**Response to Comments**

**Responses to Comment Letter A  
Terry & David Howe  
January 14, 2016**

Figure L-11

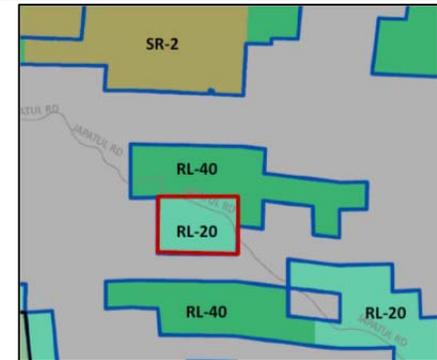
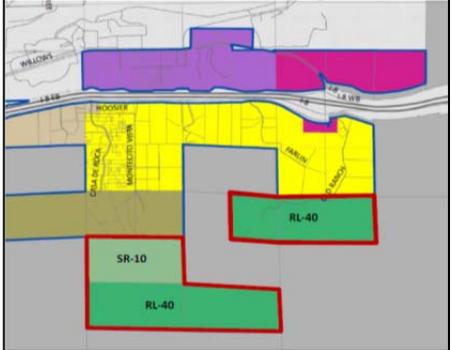
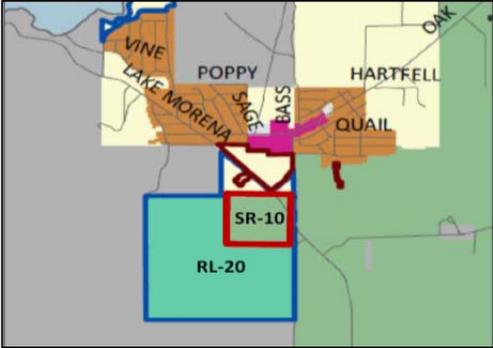
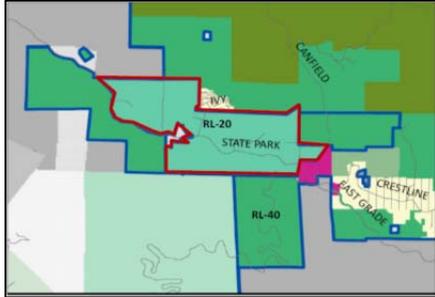
Comment	Response to Comment
L-10	<p>In addition, much the rugged former FCI lands would go from lower to higher density Rural and various Semi-Rural densities. There are some locations where the Semi-Rural designations make sense due to existing parcelization. In other areas, however, intact parcels of 40 and 80 acres and larger are being designated at higher Rural and even Semi-Rural densities (for example in Alpine). In comments on the NOP for the Project, EHL articulated several examples of such density increases:</p>	<p>The comment is not referencing the correct baseline for its comparative analysis. See Global Response 2 (GR-2). The comment will be included in the administrative record that will be considered by the decision-makers in evaluating the Project.</p>
L-11	<p><b>Alpine:</b> The area of 1:10 south of Abrams Ridge should change to 1:20.</p>	<p>The comment does not raise an issue concerning the sufficiency of the analysis in the Draft SEIR. The comment will be included in the administrative record that will be considered by the decision-makers in evaluating the Project. Ultimately, the Board of Supervisors will determine the final land use designations for the Project.</p> <p>It appears that this comment is referring to 17 parcels (outlined in red on Figure L-11, which is an excerpt from Draft SEIR Figure 1-2A) located along Japatul Road south of the Rancho Palos Verde area in the Alpine Community Planning Area (CPA). These properties are designated Rural Lands 20 (RL-20) under the proposed Project. This is consistent with the recommendations of the commenter.</p>

Figure L-60

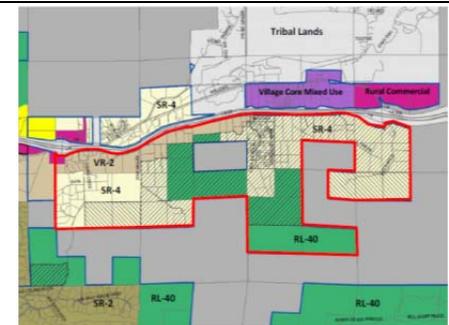
Comment	Response to Comment
L-60	<p><b>The Alpine Alternative Is Similarly Flawed</b> In the Alpine Alternative, the linear Village is extended eastward as in the Project, but otherwise the Study Area of Alpine 5, 6, and 7 retains “existing General Plan” densities (Semi-Rural and Rural). Ultimate planning would await economic studies, although such economic factors should not be determinative. Also, for Alpine 8, a split designation of RL-40 and RL-20 is applied rather than the Project’s uniform RL-20.</p>	<p>See Response to Comment L-40 in regards to the “Modified Project” alternative. This comment generally characterizes the Alpine Land Use Map alternative in Project areas east (AL-5,6,7) and south of the Alpine Village (AL-8). The Alpine Alternative Land Use Map alternative for AL-5,6,7) is shown outlined in red on Figure L-60, which is an excerpt from Draft SEIR Figure 4-3B. The Alpine Alternative Land Use Map alternative for AL-8) is shown outlined in red on Figure L-62B, which is an excerpt from Draft SEIR Figure 4-3A. (Please note that hatched areas on these figures show areas of difference with the proposed Project.)</p> <p>The comment does not raise an issue concerning the sufficiency of the analysis in the Draft SEIR. The comment will be included in the administrative record that will be considered by the decision-makers in evaluating the Project. Ultimately, the Board of Supervisors will determine whether to approve the Proposed Project or an alternative to the Project.</p>
